EL DORADO COUNTY
DEPARTMENT OF TRANSPORTATION
Contract Change Order

CCO No.	Suppl. No.	Contract No.	Contract Name	Federal Number(s)
3		8597 Project No. 36204002	Patterson Drive Emergency Culvert Repair Project	NA

Contract Change Order #3 - Sheet 4 of 5

PATTERSON DRIVE EMERGENCY
CULVERT REPAIR PROJECT

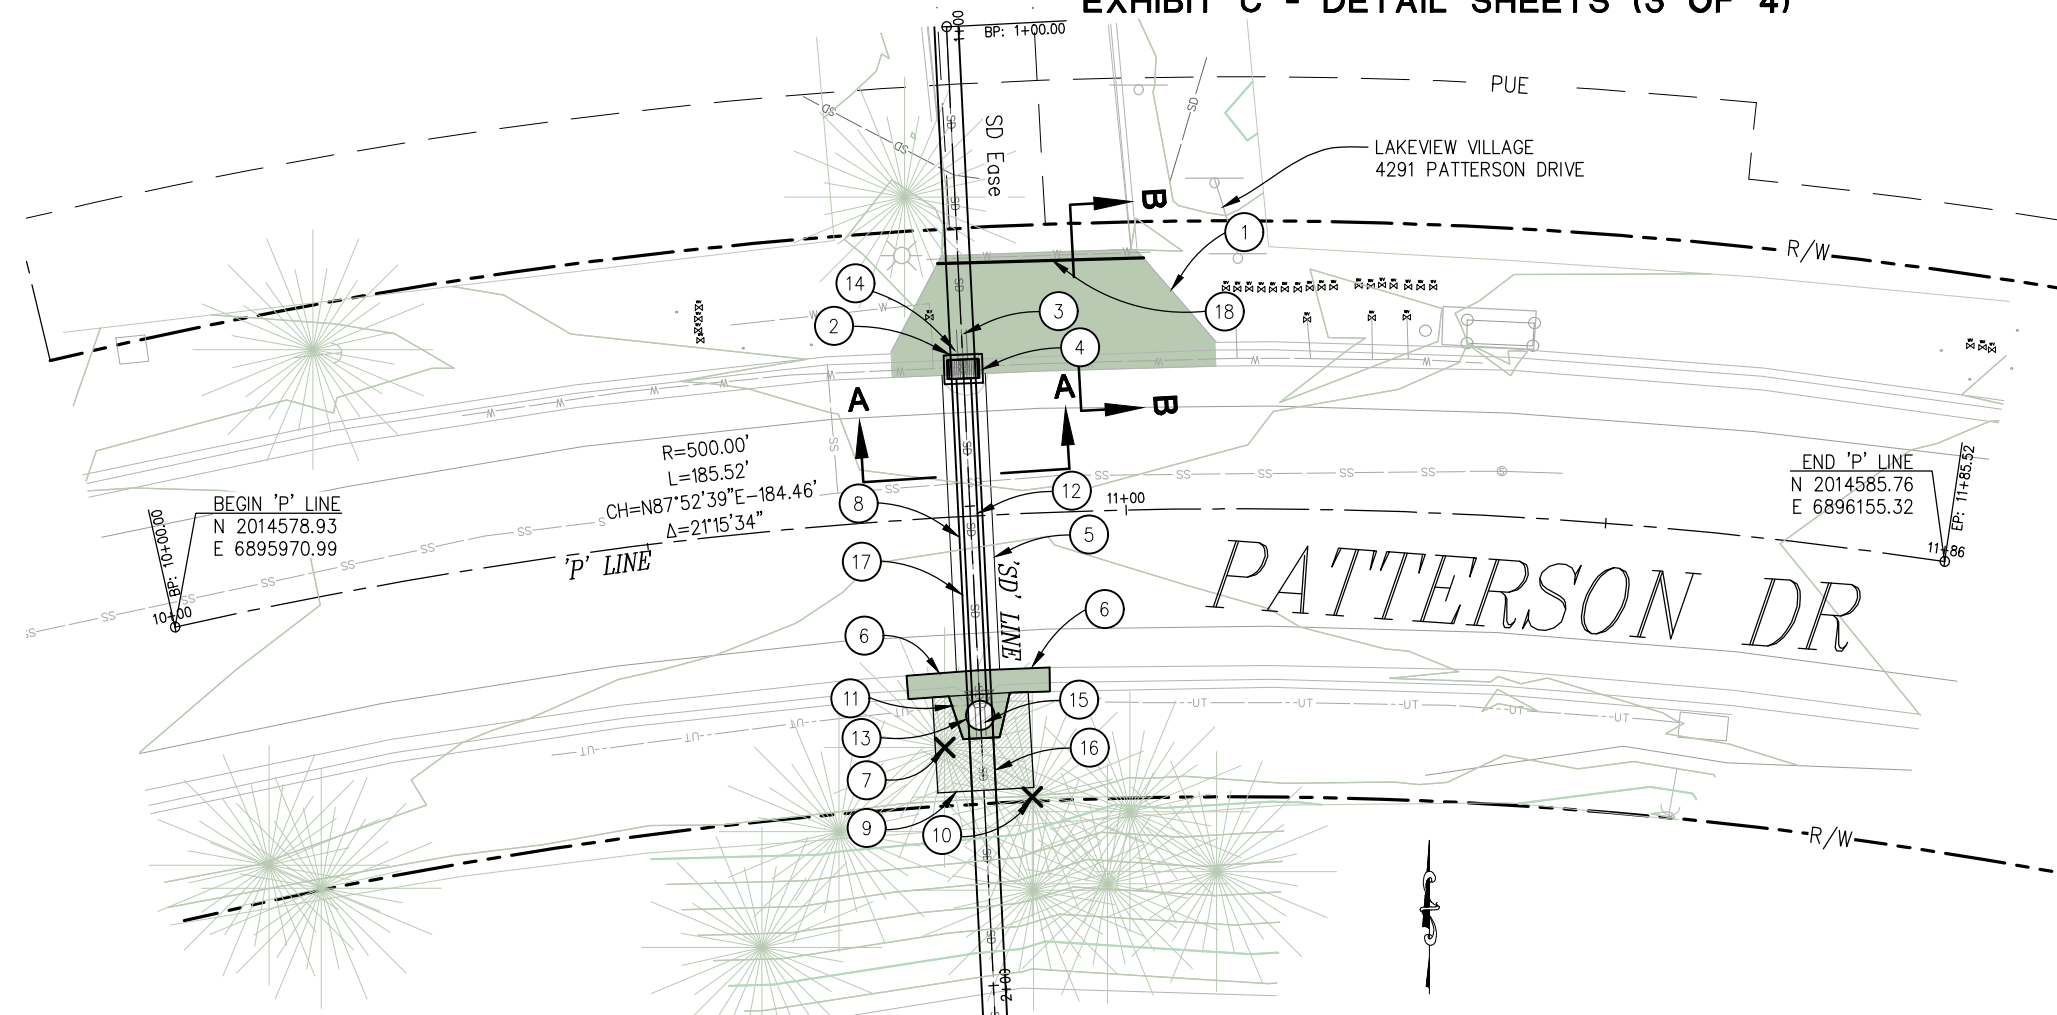
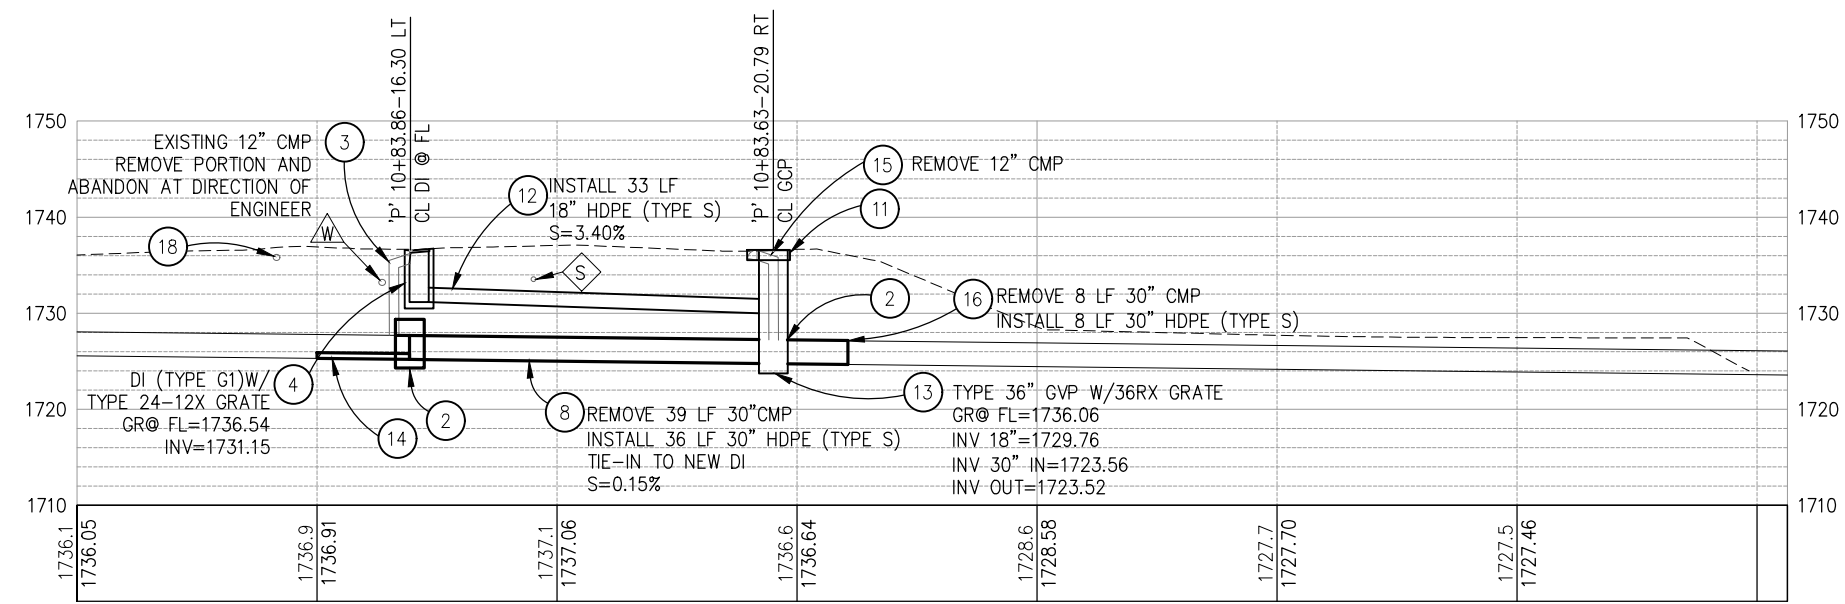
In accordance with Standard Specification 4-1.05, Changes and Extra Work, and as shown on sheets 4 and 5 of this Contract Change Order #3, revise the scope of the drainage system installation to account for over excavation and additional slurry-cement backfill due to saturated subgrade conditions caused by the failed existing 30" CMP and rainwater intrusion. Perform additional Roadway Excavation and Culvert Slurry-Cement Backfill at the following agreed quantities and Contract Bid Item Prices:

- 6 - CC03 - REMOVE AND REPLACE CURB AND/OR GUTTER (MATCH EXISTING) 20 LF BOTH SIDES OF DI. SLOPE TO DRAIN TO DI.
- 7 - REMOVE 18" STUMP.
- 8 - REMOVE 39 LF 30" CMP. REPLACE W/ 36 LF 30" HDPE (TYPE S) AND CONNECT TO GCP.

- 9 - CC03 - COVER DISTURBED GROUND WITH LEAF MULCH AND CHIP STOCKPILED PRIOR TO EXCAVATION.
- 10 - CC02 - REMOVE 12" DBH OAK TREE AND ROOT BALL.
- 11 - CC01 - TIE-IN CONCRETE APRON AND 6" CURB AND GUTTER.

- 14 - CC03 - REMOVE SATURATED MATERIAL BELOW PIPE - CAST NEW PIPE FLOWLINE WITH 6-SACK CONCRETE REINFORCED WITH 6" WELDED WIRE MESH AS DIRECTED BY ENGINEER.

- 18 - CC03 - REPLACE UNMARKED EXISTING $\frac{3}{4}$ " IRRIGATION LINES WITH 4" PVC CONDUIT CONTAINING TWO $\frac{3}{4}$ " IRRIGATION LINES TIED INTO EXISTING LINES ON EACH SIDE OF DRIVEWAY.
